CALIFORNIA ENERGY COMMISSION

DOCKET	
09-AFC-7	
DATE	<u>APR 13 2010</u>
RECD	<u>APR 13 2010</u>

Please be advised that the Energy Commission and Bureau of Land Management staff met at the Palen proposed site on April 8, 2010 with staff from the California Department of Fish and Game and the U.S. Fish and Wildlife Service. The purpose for this visit was to evaluate potential lands that could be added to the staff's reduced acreage alternative presented in the Palen Solar Power Project Staff Assessment/Draft Environmental Impact Statement (SA/DEIS).

REVISED ALTERNATIVE FOR CONSIDERATION

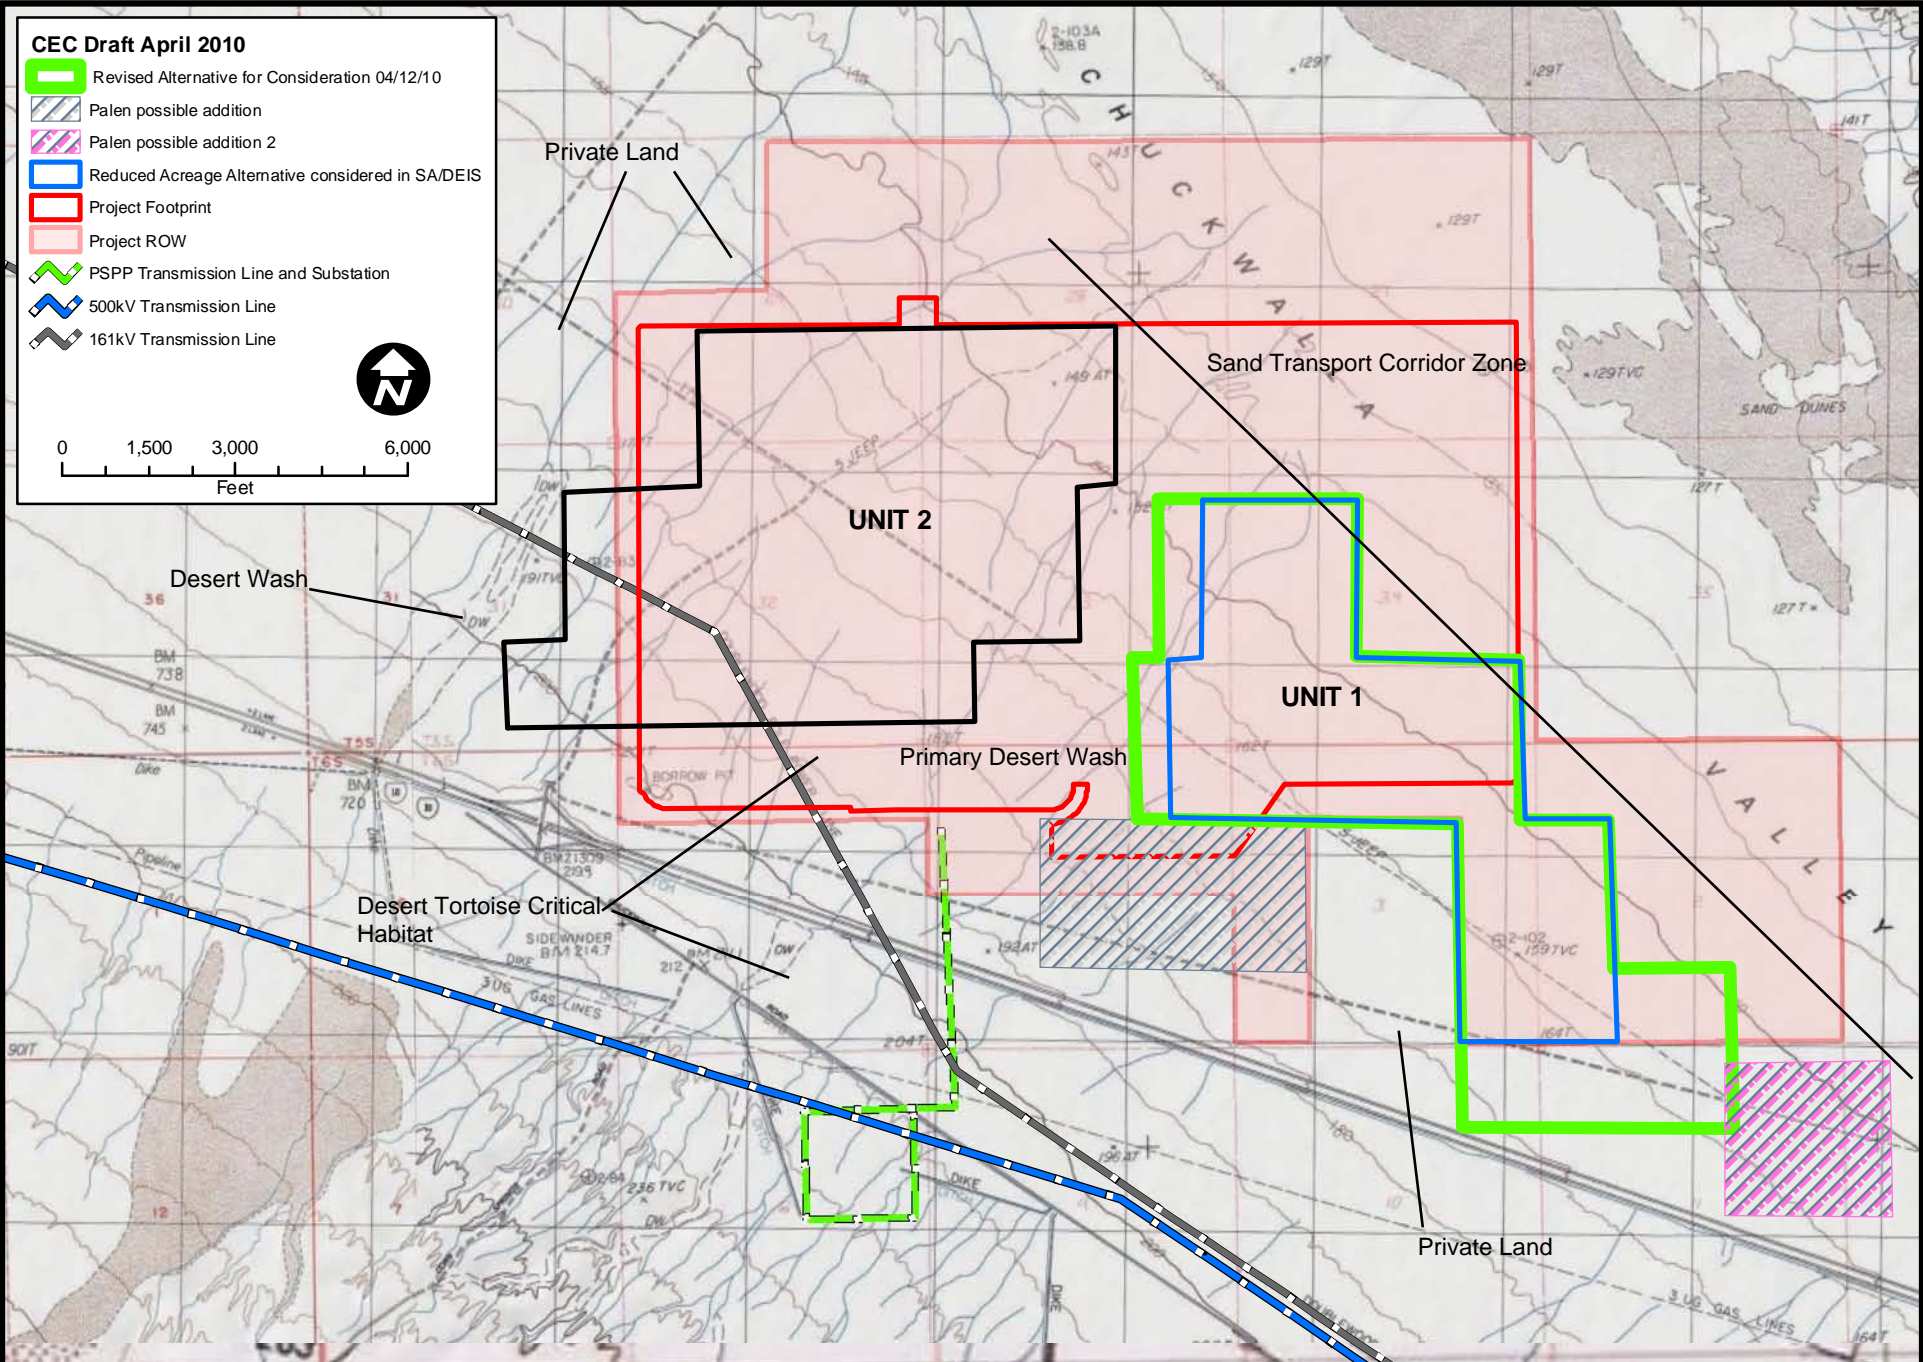
With the goal of identifying a project configuration that both avoids the sensitive biological resources identified in the SA/DEIS and attains, as close as possible, the megawattage originally proposed, Energy Commission staff have identified an additional possible alternative configuration for the Palen Solar Power Project. I wanted to provide you with a copy of this alternative so that you and your staff have time to review it prior to the April 16, 2010 Workshop so that the parties can engage in meaningful dialogue concerning the technical feasibility of this alternative.
